BURFELL PROJECT

GENERAL APPRAISAL

**SWISS ALUMINIUM LTD.
ELECTRO-WATT
ZURICH**

NOVEMBER 1963

THE STATE ELECTRICITY AUTHORITY ICELAND		
BURFELL PROJECT		
ALTERNATIVE SCHEME - LONGITUDINAL-SECTION		
ELECTRO - WATT ZÜRICH	PROJ. <i>Bru</i>	DATE: NOV. 1963
	DRAWN <i>Hof</i>	NO: 50 394

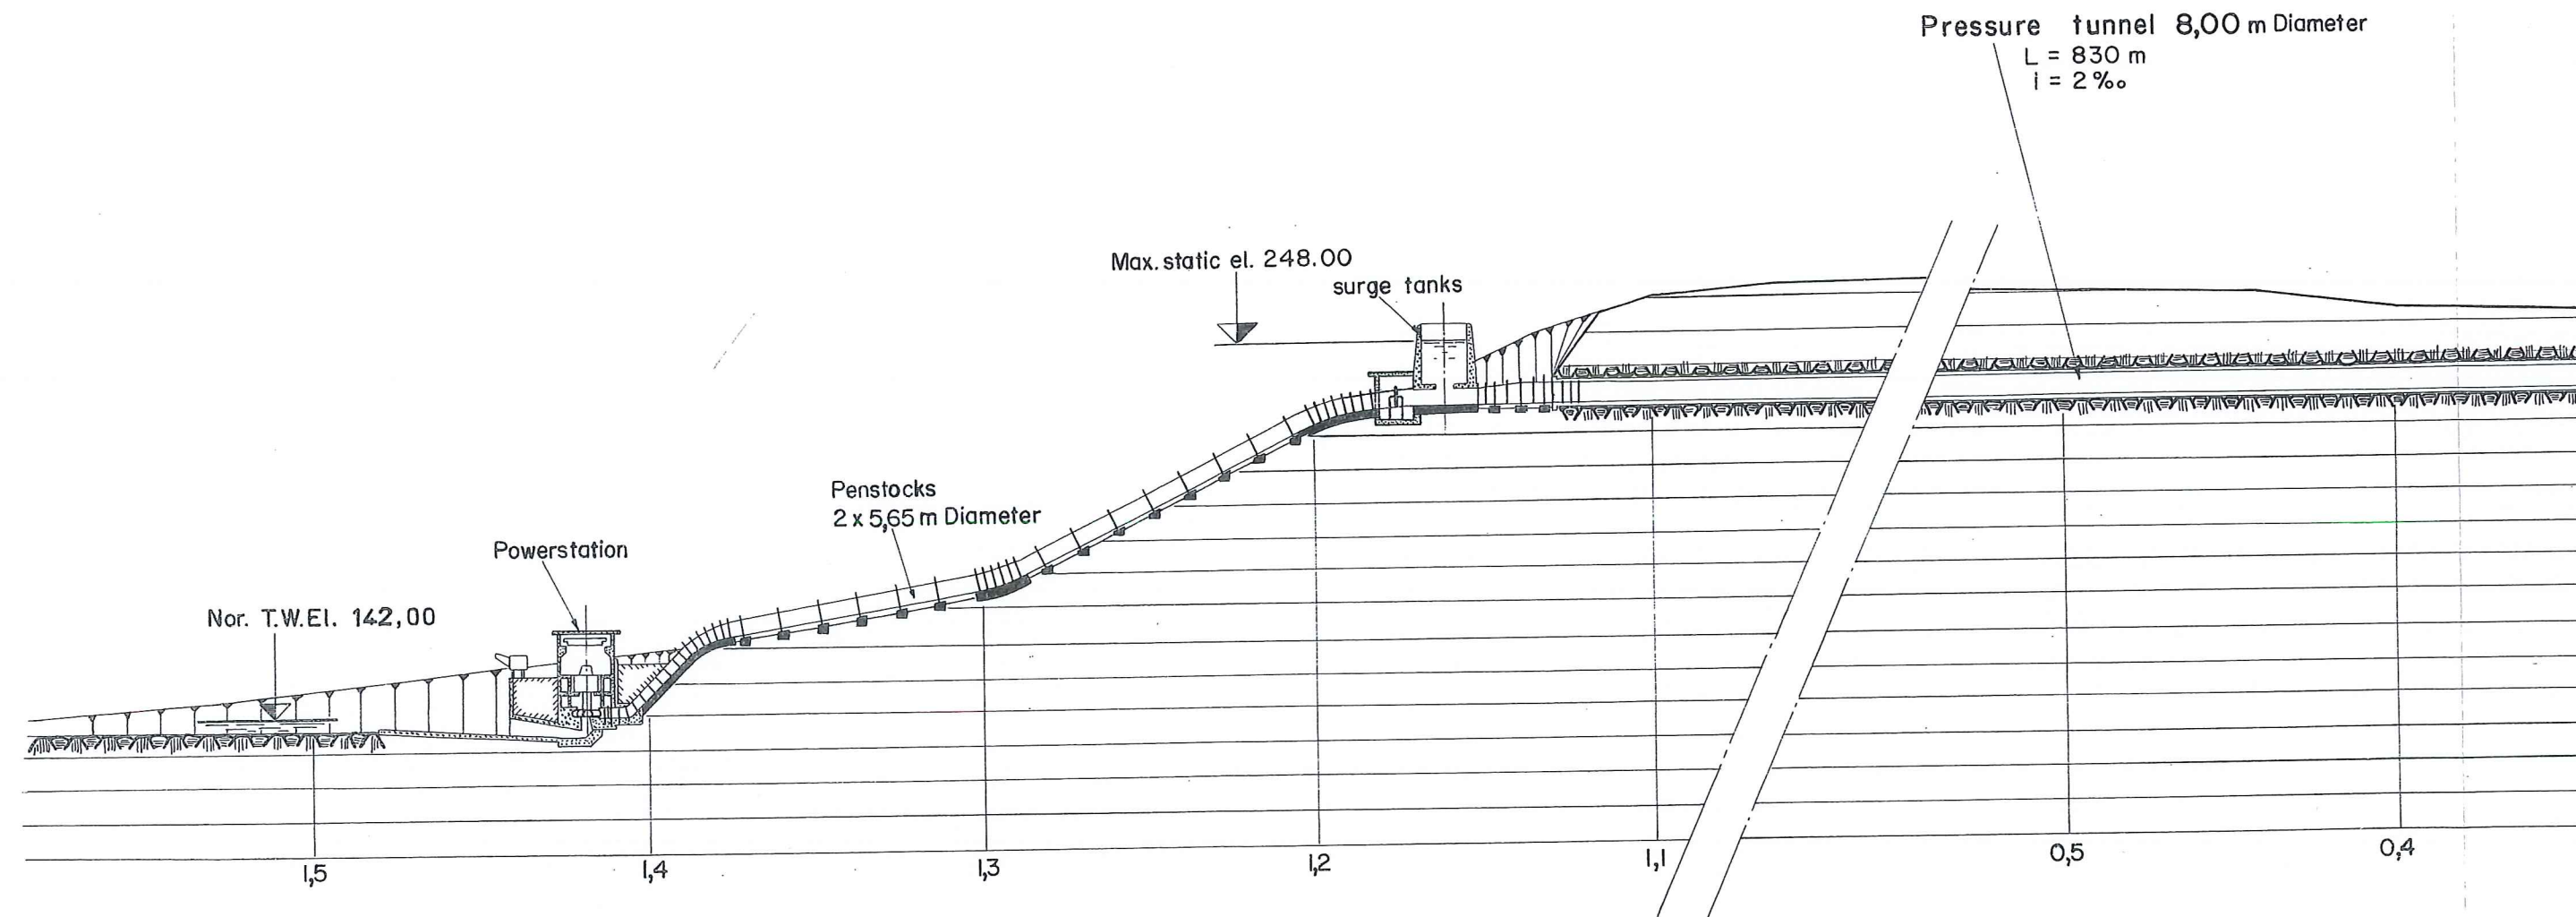
It appears that a headrace development with a powerhouse located near the bottom end of the Samsstadaklif would reduce the waterways considerably (900 m long head-race against 1700 m long tail-race) while the head developed would be only 15 percent less. The scheme suggested along these lines is shown on drawings no. 50393 and no. 50394. Diversion dams, intake and sluiceway would be located as in the Harza's Scheme C.
